# UNITED STATES PATENT AND TRADEMARK OFFICE

10/554,182

<b>Office Action Summary</b>	<b>Application No.</b> 10/554,182	<b>Applicant(s)</b> JAMES, DUGAL SIMON STEWART	
	<b>Examiner</b> JAY R. SIGLER	<b>Art Unit</b> 3775

## **DETAILED ACTION**

FIG. 7

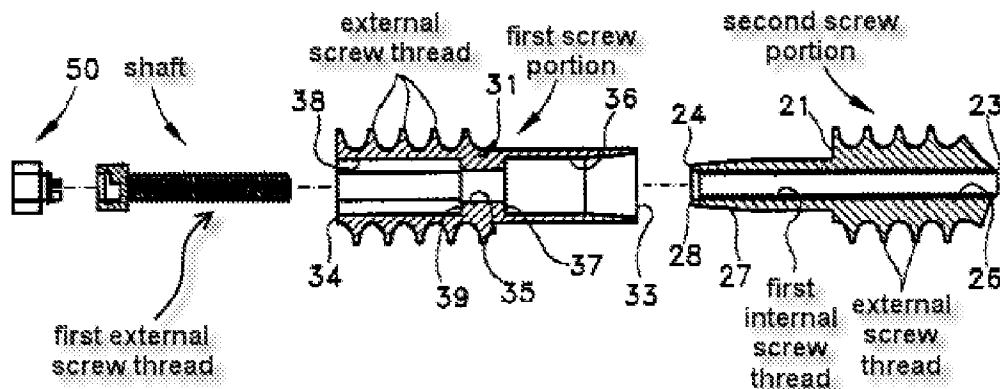
a. Concerning claims 15, 16, 17, and 19: Bramlet discloses a longitudinal shaft having a head and a longitudinal axis; a first screw portion rotatable about said longitudinal axis; a second screw portion rotatable about said longitudinal axis independently of said first screw portion, wherein said first and second screw portions each have an external screw thread configured to engage a bore formed in the first and second members (see Fig. 2 in Bramlet and modified Fig. 7 below).

Bramlet discloses retaining member 50 that mates with a surface/portion 38 in the first screw portion and is used to preclude rotation of the shaft relative to the first screw portion, but not specifically a retaining member being a screw or

Michelson, however, suggests a retaining screw 130 that mates with an internal thread 118 and is used to prevent backing out of a longitudinal shaft 100 and thus substantially prevents rotation of said shaft. It would have been obvious to someone of ordinary skill in the art at the time of the invention to substitute the retaining member and first screw portion surface in the invention of Bramlet with the retaining member, i.e. screw, and surface, i.e. internal thread, of Michelson, because the substitution would have yielded predictable results, i.e. prevent back out of the longitudinal shaft and thus substantially prevent rotation of the shaft.

b. Concerning claim 18, 23, and 24, Bramlet further discloses element 250, which can be considered a lock nut; the shaft would be at least flexible to a small degree; and first and second members are bone (see Fig. 2);

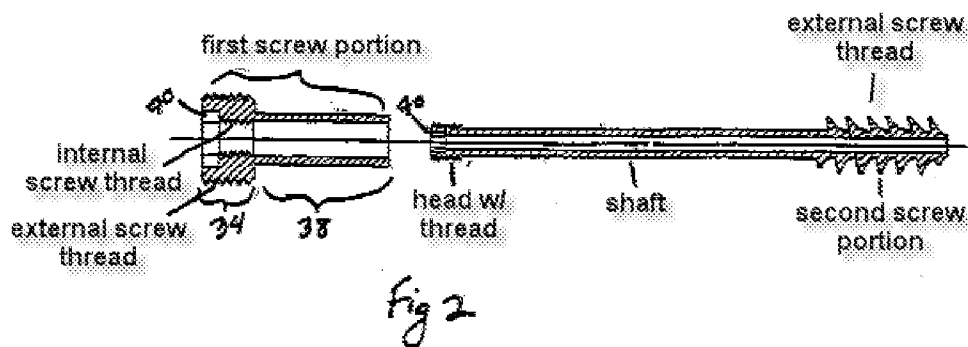
c. Concerning claim 20, Kyle discloses a shaft having a head and a longitudinal axis; an external screw thread on said head; a first screw portion having an internal screw thread for engaging said first external screw thread; and a second screw portion; wherein the first and second screw portions each have an external screw thread (see modified Fig. 2 below).

Kyle does not specifically disclose a retaining screw.

Michelson, however, suggests having a retaining screw 130 that mates with an internal thread 118 in order to prevent backing out of a longitudinal shaft 100 and thus substantially preventing rotation of said shaft. It would have been

obvious to someone of ordinary skill in the art at the time of the invention to add a retaining screw and additional internal thread to the first screw portion in the invention of Kyle in order to prevent backing out of the longitudinal shaft and thus substantially preventing rotation of said shaft as suggested by Michelson.
